SWAG 40 02 0025

to fit:
 Vauxhall Corsa B, Tigra A,
 Astra F 1.4 16V and 1.6 16V,
 also Vectra B 1.6 16V and 1.8 16V

Timing belt kit

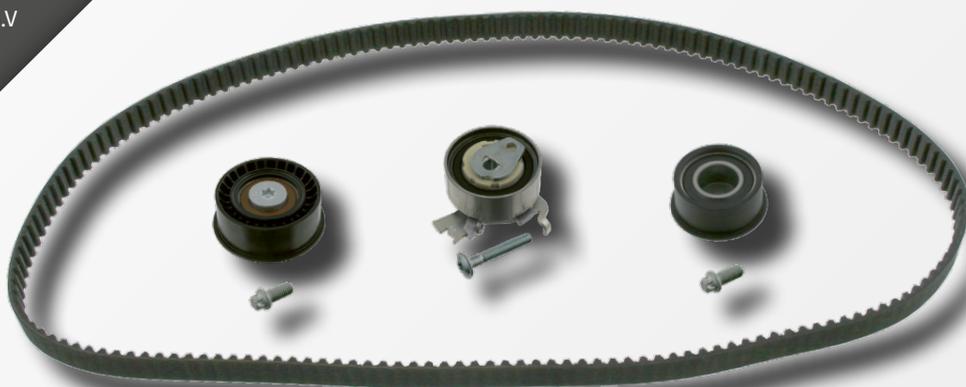
The timing belt can break.

The design of the belt pulley has been changed by the vehicle manufacturer. The slightly raised section of the old belt pulley (refer to picture 1) can cause a faster deterioration of the timing belt edge. This causes the timing belt to move and be prematurely torn, leading to serious engine damage.

SWAG recommends: before fitting the timing belt kit SWAG 40 02 0025, check for a raised part of the belt pulley and, if necessary, replace with the new version (refer to picture 2) (Vauxhall plan 5614 430). The new belt pulley will fit correctly to the timing belt, thereby guaranteeing a longer life span.

Please note: when you replace the belt pulley, the crankshaft gear (refer to picture 3) (Vauxhall 0614 546) and the stretch bolt (refer to picture 4) (0614 932 Torx) should also be replaced.
